October 30, 2020

West Flemish Pass Exploration Drilling Project
Impact Assessment Agency of Canada
901-10 Barters Hill
St. John's, NL, A1C 6M1

Re: WWF-Canada's Submission to the IAAC on the WEST FLEMISH PASS Exploration Drilling Project Environmental Assessment Report

Figure 1: Oil spill risk matrix with low-probability/low-impact events in the lower left corner (low risk) and high-probability/high-impact events in the upper right corner (high risk).

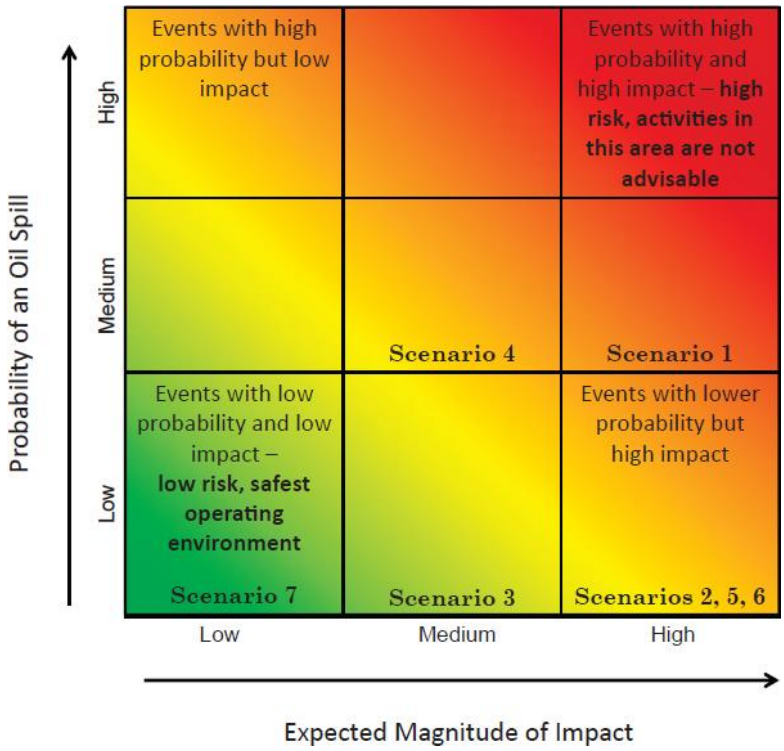
On page 51 of the EA, the Agency acknowledges that the potential effects from a worst-case accident would be "more severe" than what the proponent has claimed in its EIS, but the IAAC errs in not considering how the adverse consequences of a major spill would fundamentally change the overall risk assessment of the project. Utilizing a standard risk matrix, we can estimate that, although the probability of a major spill would be low, the magnitude of such an event make the overall risk level medium to high.
